APPLICATION NO.	FILING DATE	FIRST NAMED INVENTOR	ATTORNEY DOCKET NO.	CONFIRMATION NO.
10/575,730	12/21/2006	Artur Grunwald	GKNG 1282 PCT	4609
27256	7590	03/18/2009	EXAMINER	
Dickinson Wright PLLC 38525 Woodward Avenue Suite 2000 Bloomfield Hills, MI 48304			LIGERAKIS, JOHN	
			ART UNIT	PAPER NUMBER
			3655	
			MAIL DATE	DELIVERY MODE
			03/18/2009	PAPER

Office Action Summary	Application No. 10/575,730	Applicant(s) GRUNWALD ET AL.	
	Examiner John V. Ligerakis	Art Unit 3655

DETAILED ACTION

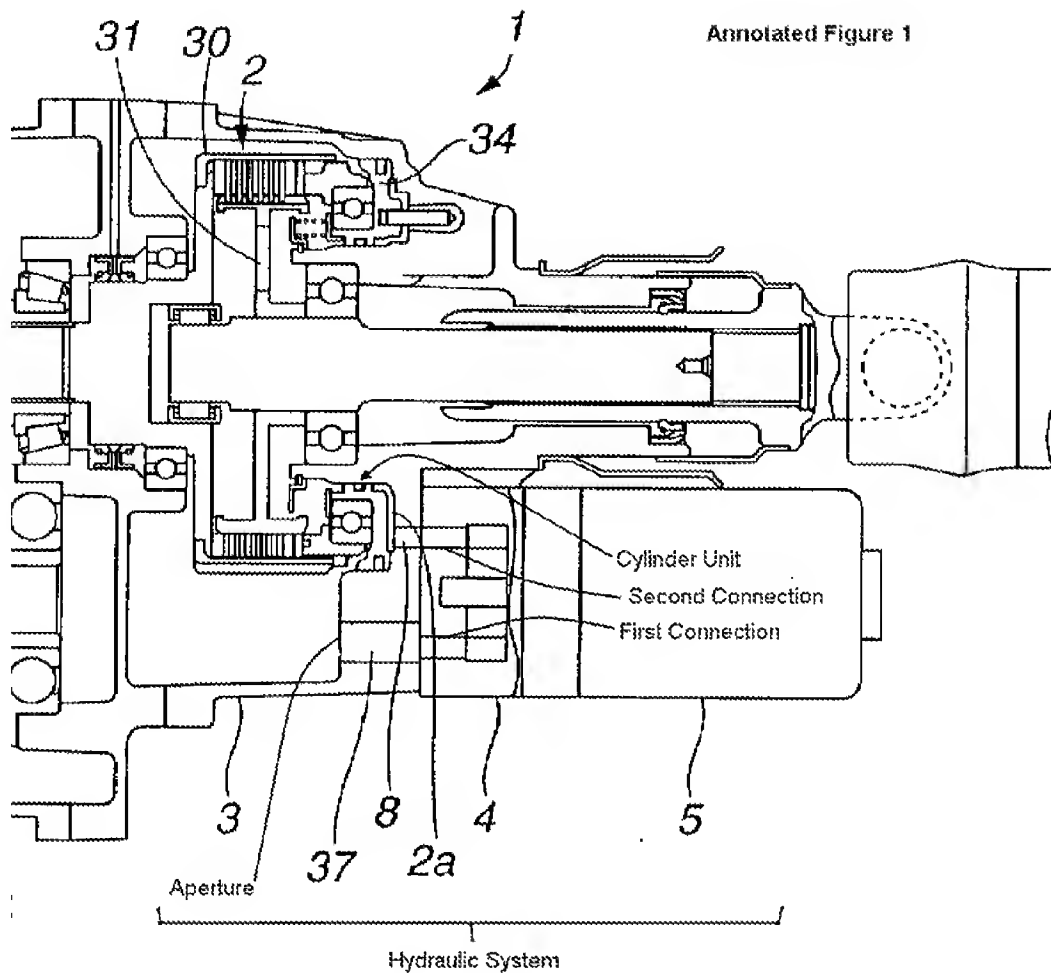
Regarding claims 15, 25, and 27, Sakata et al. discloses (See Annotated Figure 1) an axial setting device (1) for actuating a multi-plate coupling (2) in the driveline of a motor vehicle, comprising: a housing (3) in which there are supported two parts (30,31)

so as to be coaxially rotatable relative to one another, which two parts (30,31) can be coupled to one another by the multi-plate coupling (2) arranged in the housing (3); a cylinder unit with a hydraulic chamber (2a) and a piston (34) which is arranged in the hydraulic chamber (2a) so as to be axially displaceable and which is provided for actuating the multi-plate coupling (2); a hydraulic system for supplying the cylinder unit, comprising a quantity of oil jointly contained in the housing (3) and in the hydraulic chamber (2a), and a pump (4) having a first connection connected to the housing (3) and a second connection connected to the hydraulic chamber (2a), wherein the pump (4) is firmly connected to the housing (3), and in the housing (3), there is provided an aperture connecting the first connection to an interior of the housing (3) and a channel (8) connecting the second connection to the hydraulic chamber (2a); an antechamber (37) in the housing (3) between the aperture and the first connection; the antechamber permits the supply of fluid from the housing to the first connection. Sakata et al. fails to disclose a filter located between the housing and the first connection. Gassmann discloses a hydraulic torque transfer device (See Figure 1) wherein a filter (102) is in an aperture in the hydraulic system (26) between the housing (12) and the first connection (104) of the pump (24). It would have been obvious to one of ordinary skill in the art at the time of the invention to provide the aperture in the hydraulic system disclosed by Sakata et al. with a filter in view of Gassmann in order to improve oil filtration.

Regarding claim 16, Sakata et al. discloses an axial setting device wherein the pump (4) is adapted to convey oil from the housing (3) to the hydraulic chamber (2a) and vice versa.

Regarding claim 21, Sakata et al. discloses an axial setting device as set forth above, wherein the channel (8) is provided in the housing (3) only.

Regarding Claim 34, Sakata et al. discloses an axial setting device as set forth above, wherein the pump (4) can be driven by an electric motor (5) and is controllable (See Fig. 1) by an electronic control unit (7).

Regarding claim 35, Sakata et al. discloses an axial setting device as set forth above, wherein the pump (4) and the electric motor (5) form one unit and are positioned on a common longitudinal axis.
